SERVICE BULLETIN

APPLICABILITY: 2017-18MY Forester 2.5L

NUMBER: 09-84-22

SUBJECT: Exhaust Pipe Front (EPF) Replacement

Description of Changes:

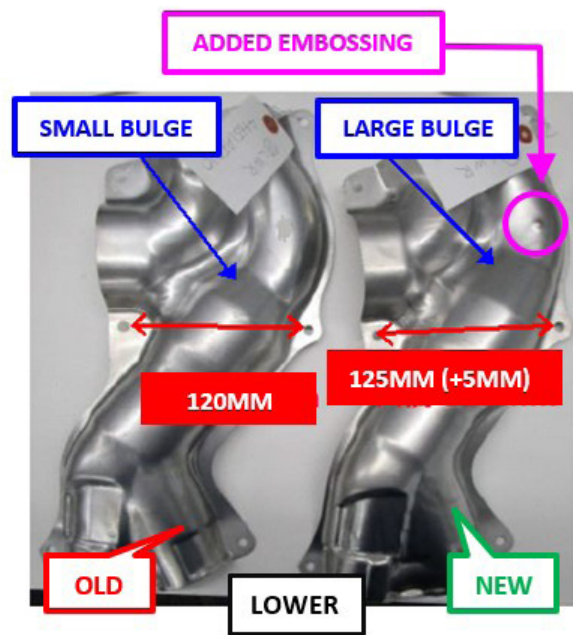
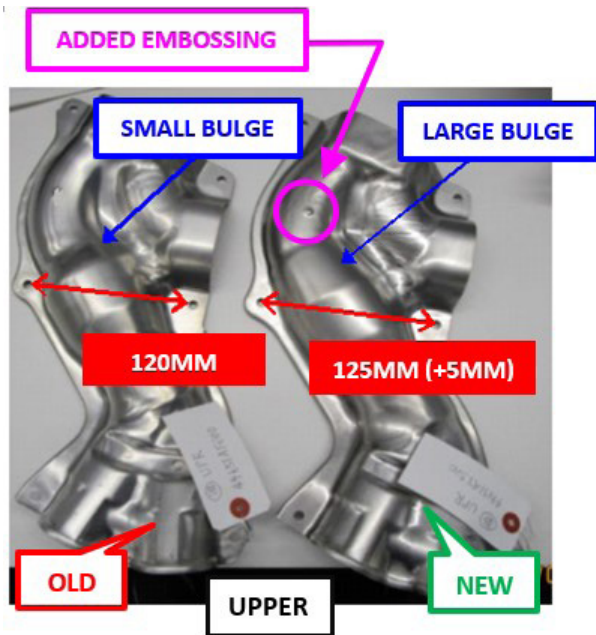
Part Description	Number	Areas of Change	Details
Front Exhaust Pipe (CONVERTER COMPLETE-FRONT)	1	Bellows	Material Change
	2	Holder	Re-Shaped
	3	Upstream Holder	Re-Sized
	4	Downstream Holder	Re-Sized
	5	Upper Elbow	Re-Shaped
	6	Lower Elbow	Re-Shaped
Upper Cover (COVER COMPLETE-CONVERTER PIPE FRONT)	7	Upper Cover	Re-Shaped (Described Next Page)
Lower Cover (COVER COMPLETE-CONVERTER PIPE FRONT)	8	Lower Cover	Re-Shaped (Described Next Page)
